PROJECT: Summiton West V22 - Kestrel Creek Avenue (Street 1)

CITY OF LAS VEGAS		DATE:
INTER-OFFICE MEMORANDUM		December 2, 2019
TO: Land Development Services Department of Building & Safety		FROM: Albert Sung, P.E. Flood Control Project Engineer Department of Public Works
SUBJECT:	COPIES TO:	
Drainage Study for:	Atkins	
Summerlin West V22 – Kestrel Creek Avenue (Street I) (from Desert Foothills Drive to Kettle Ridge Drive <Street J>)		
Cross Streets:	Desert Foothill Drive & Kestrel Creek Ave.	Howard Hughes Company, LLC
File Number:	F:\Depot\DSMemos\DS5171C.doc	Bart Anderson, P.E., DevCo
Parcel Number:	137-14-401-006 & 137-23-101-002	
Zoning Action:	N/A	
FEMA Flood Zone	YES	NO X
Proposed Storm Drain	YES X	NO

Kestrel Creek Avenue (Street I): Desert Foothills
Drive to Kettle Ridge Drive (Street J)
Technical Drainage Study

Supplement #1 to Addendum #1

"KCA" STA. 17+64 SEE SHEET 14

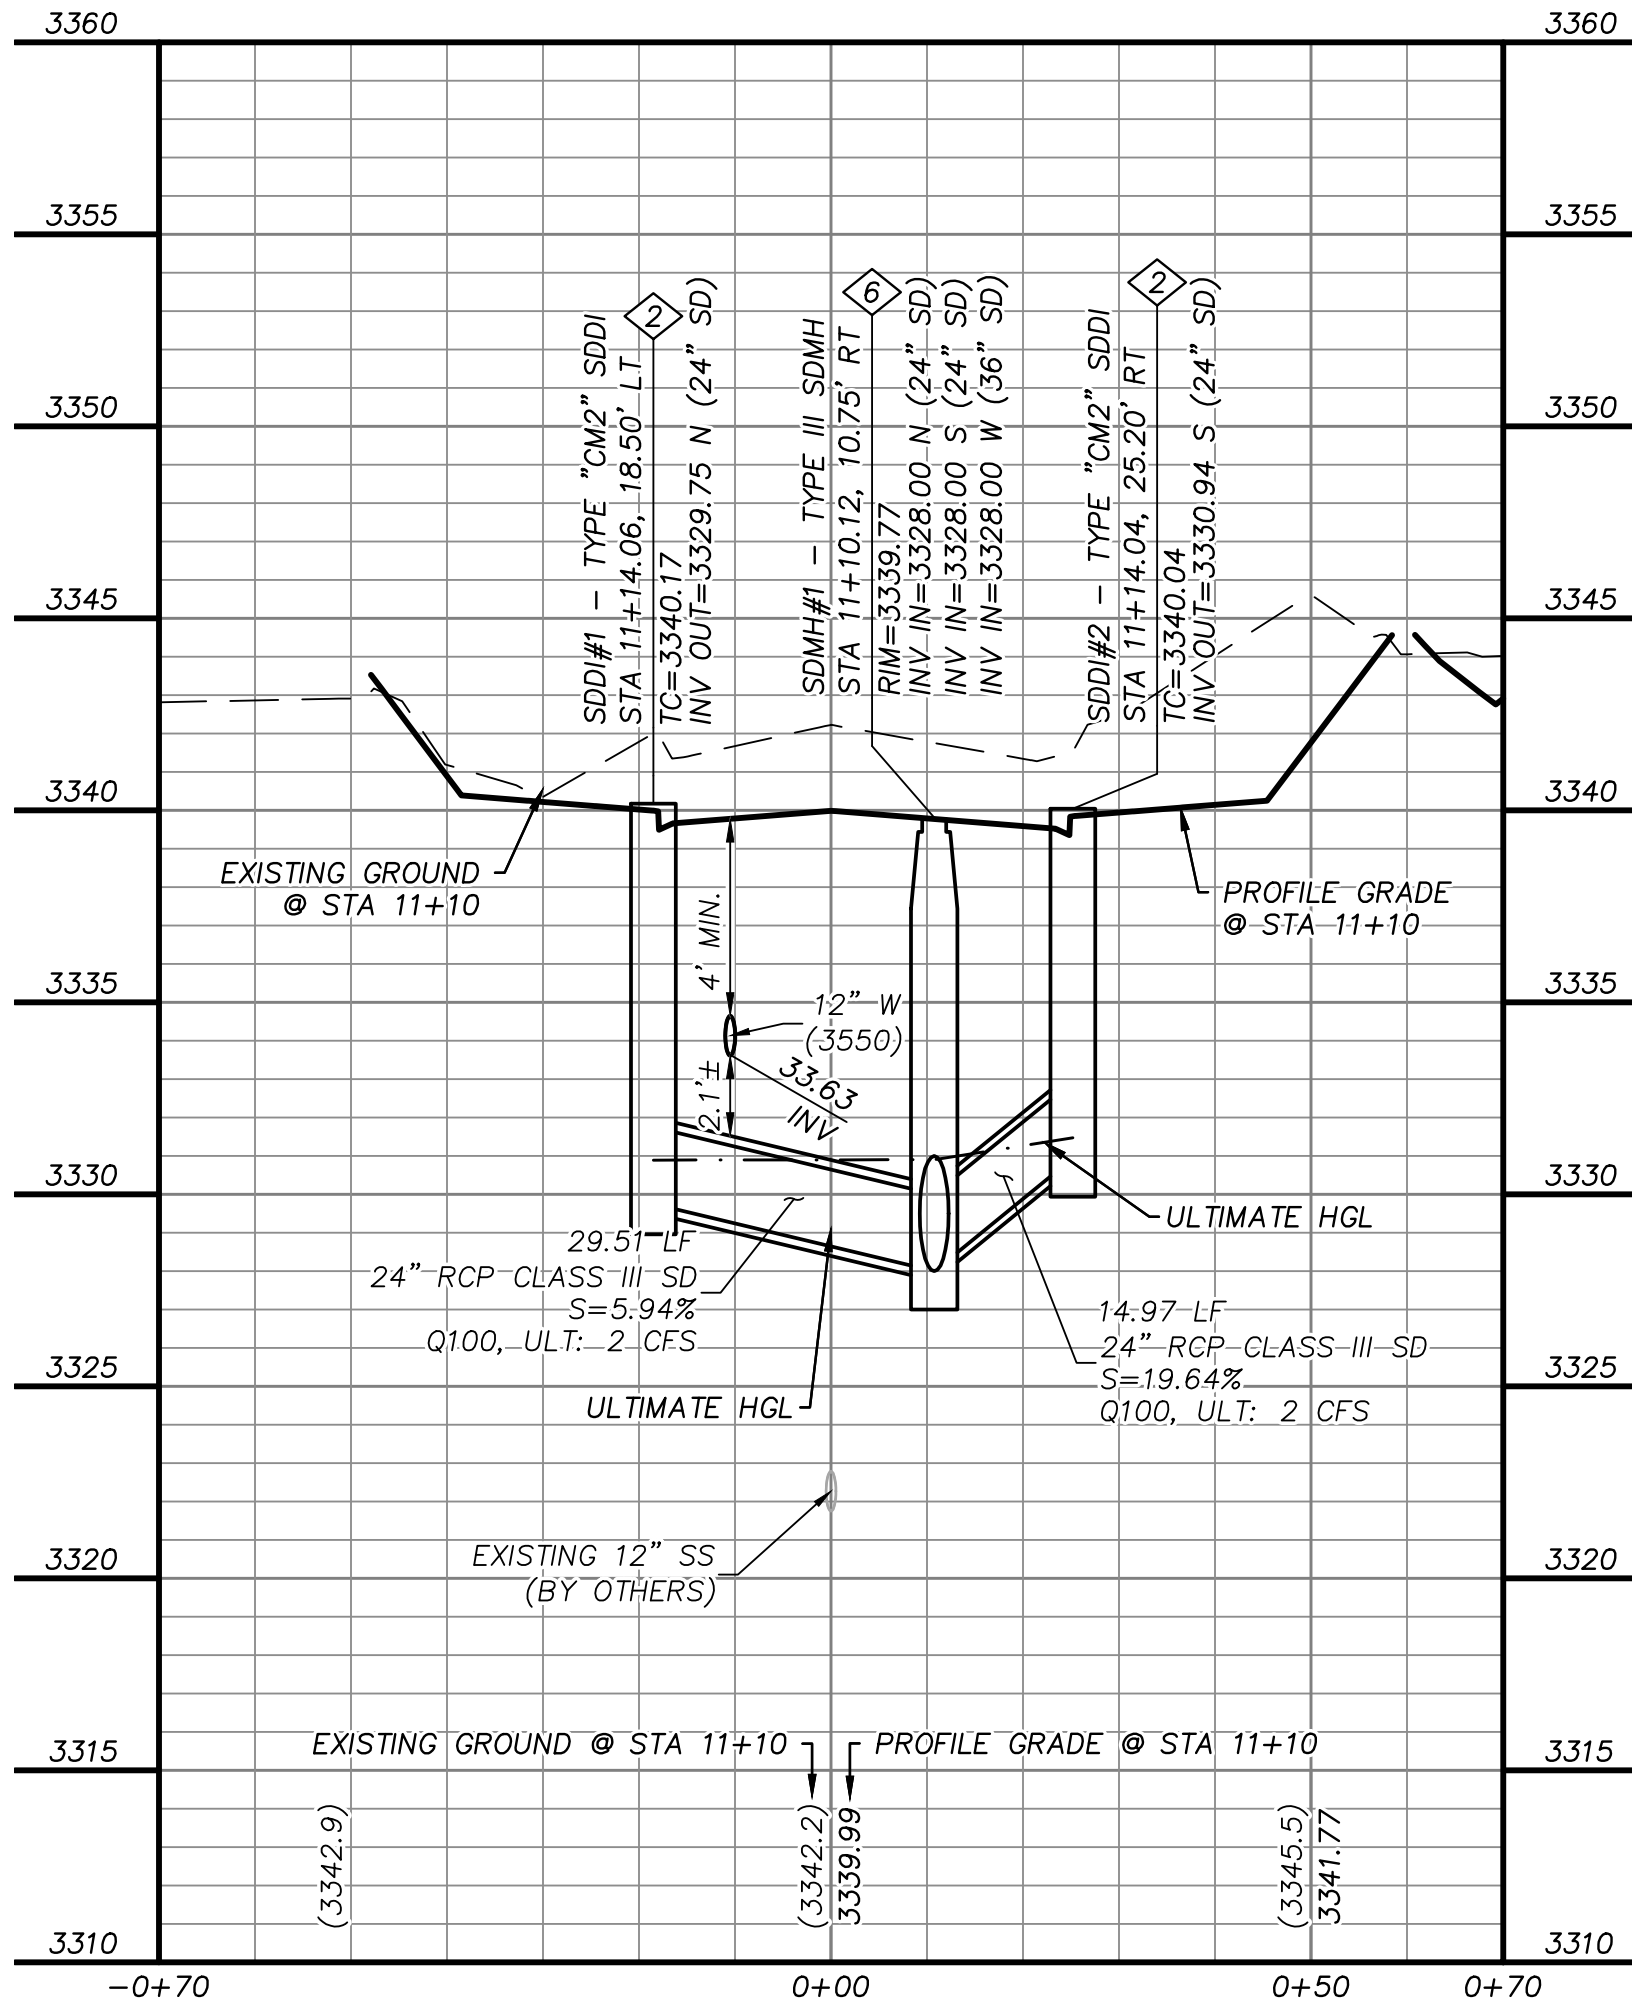
On Sheet 21/31, since you did not label the depth of the inlets clearly, I went on visually measuring the depths from the profile and found that the inlets are more than 10' deep from the flow line to the bottom. So label the depth of each inlet clearly and revise the profile to visually convincing.

The response that all drop inlets had been modified to less than 10' in depth was found not true. Per Sheet 21/31 (Storm Drain Lateral Profiles), proposed drop inlets SDDI #1, SDDI #2, and SDDI #4 are schematically shown to be deeper than 10'. This must be resolved prior to the final approval of the study.

Comment response: The drop inlets proposed by this report have been modified and are all under 10' deep from flow line to invert out per CCAUSD Dwg. No. 412.1.
